ADDENDUM 3

MERIDIAN TECHNOLOGY CENTER
ZONE B ROOF & HVAC REPLACEMENT
1312 S Sangre Road
Stillwater, OK 74074

ADDENDUM NO. 3

April 21, 2023

AD-111

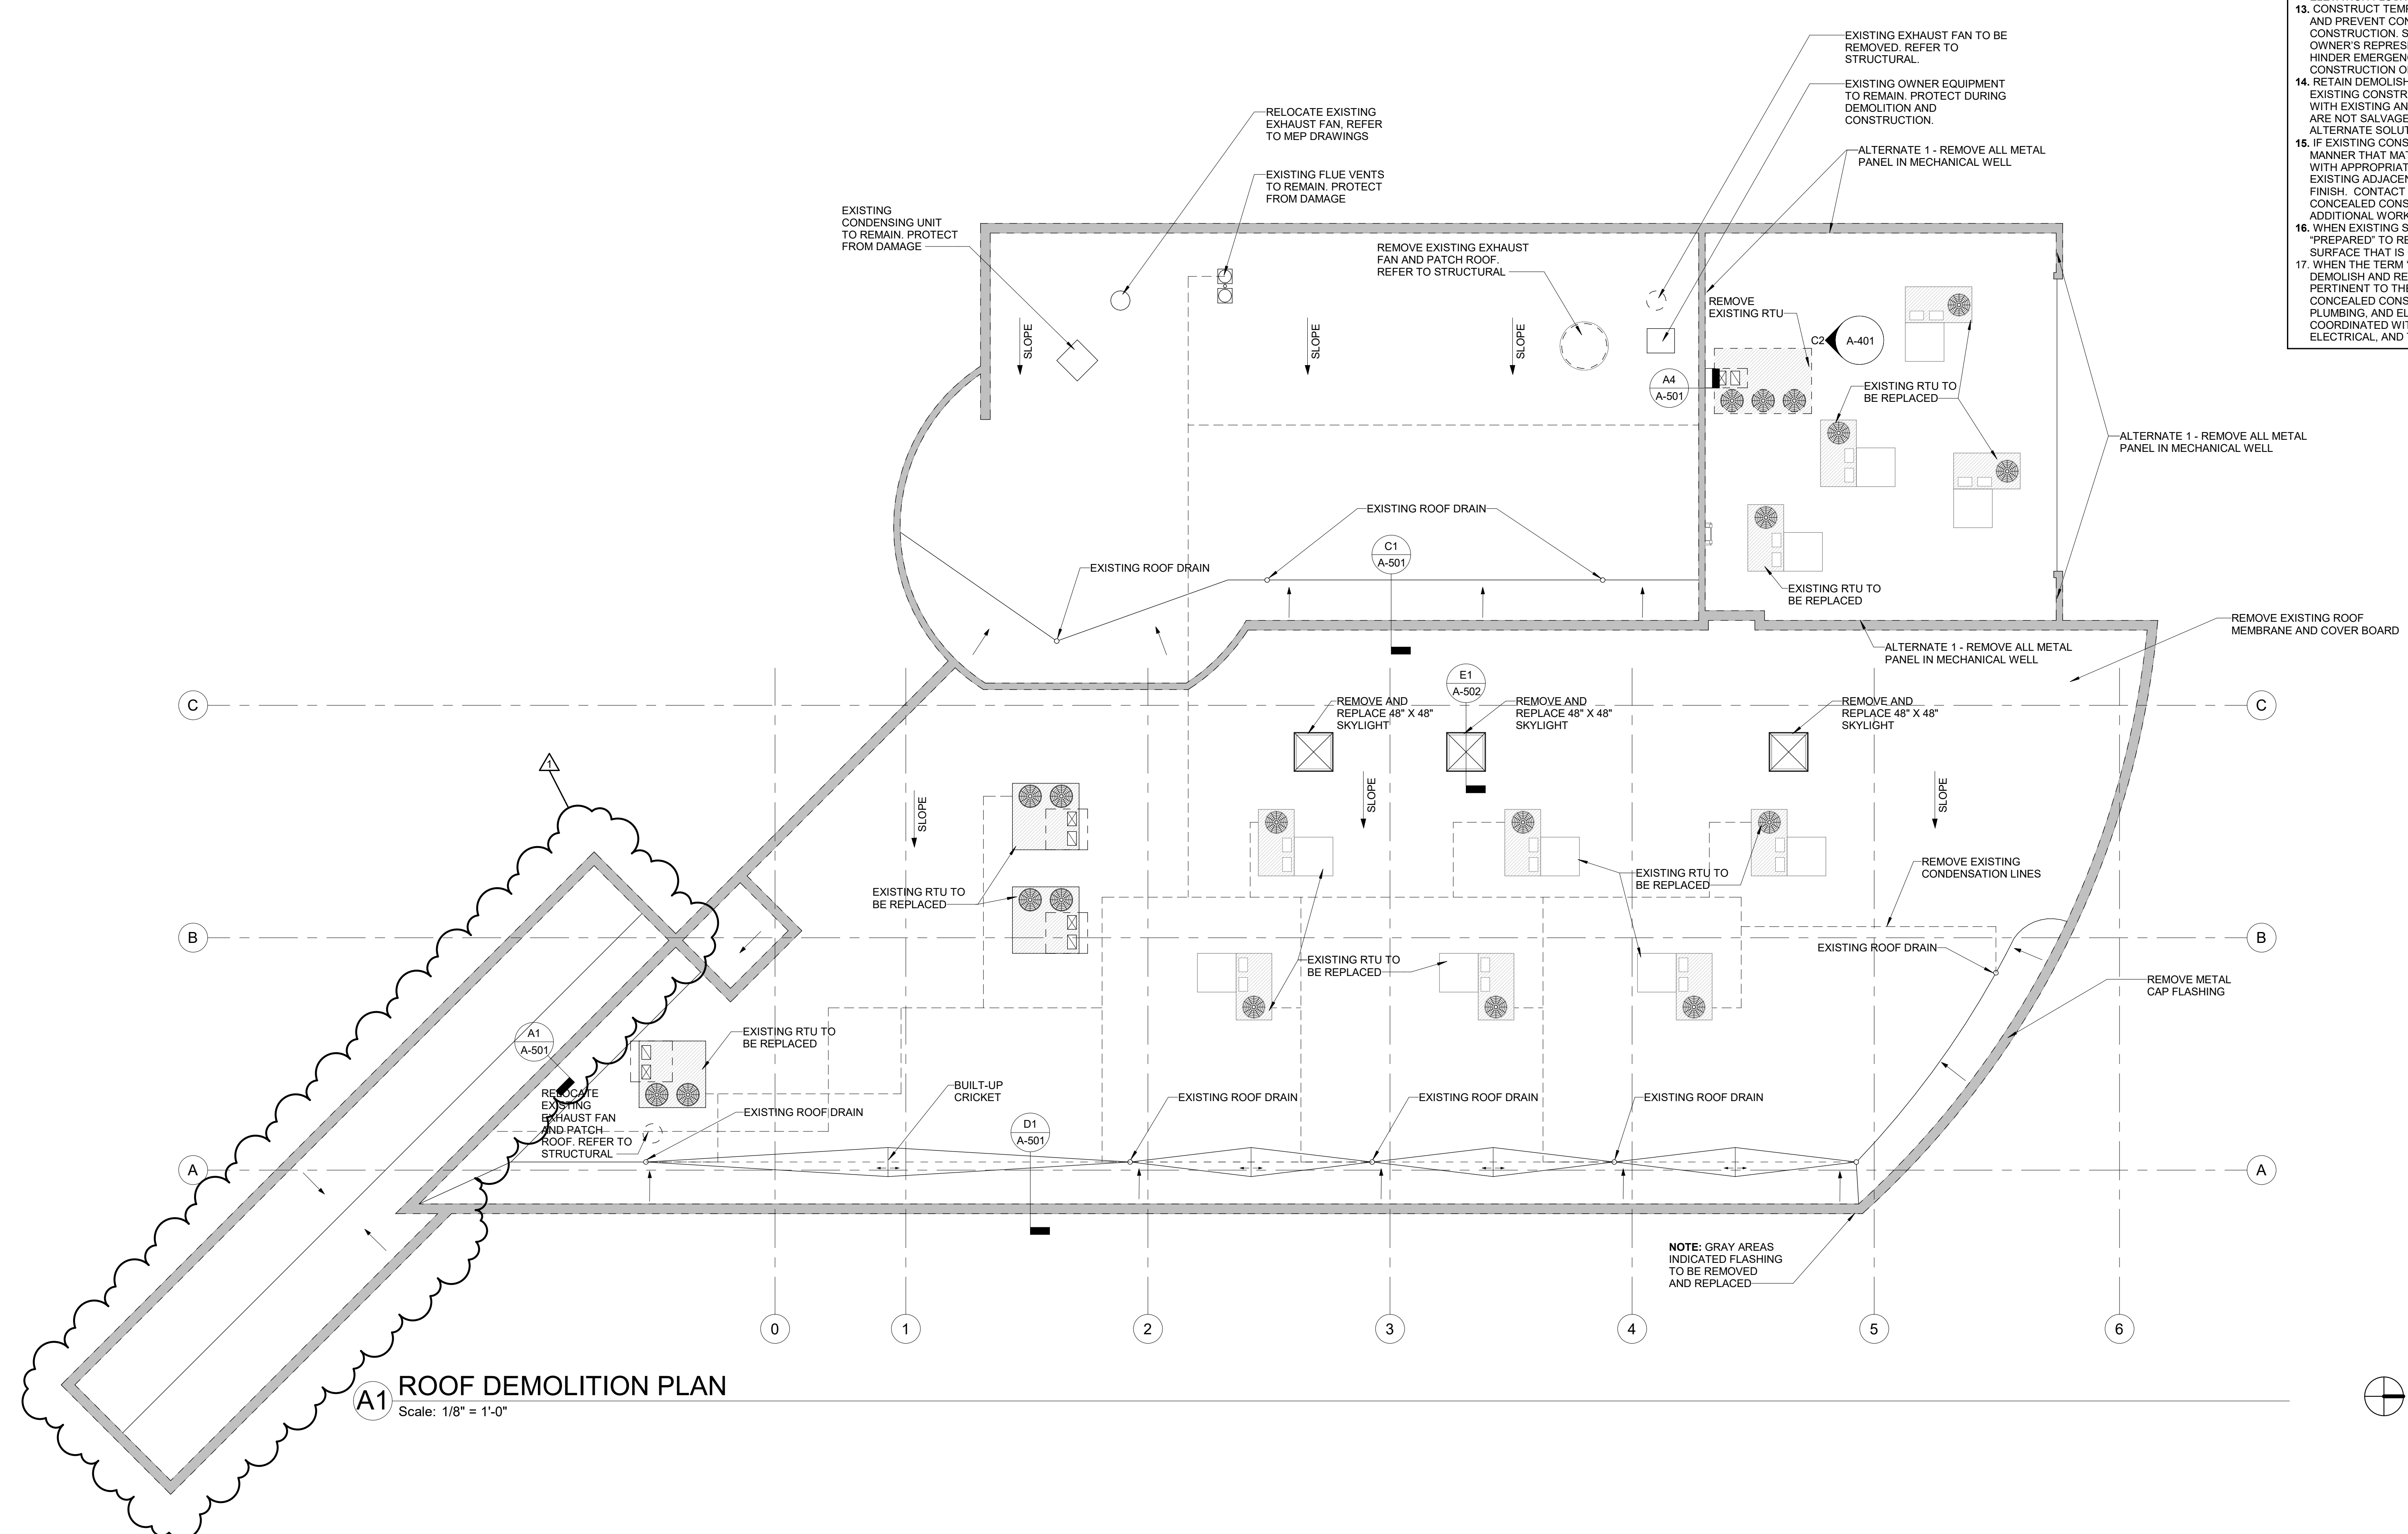
2. Sheet AD-111 indicates the removal of the existing roof membrane and cover board for this building. Can clarification regarding which areas of the roof are to be removed and replaced? Is the entire upper level of roof membrane and cover board to be part of this contract?

- a. **The entire roof shown (both upper and lower levels) on revised sheet AD-111 is included in the contract, including the additional clouded area included with this addendum, shown on both sheets AD-111 and A-111.**
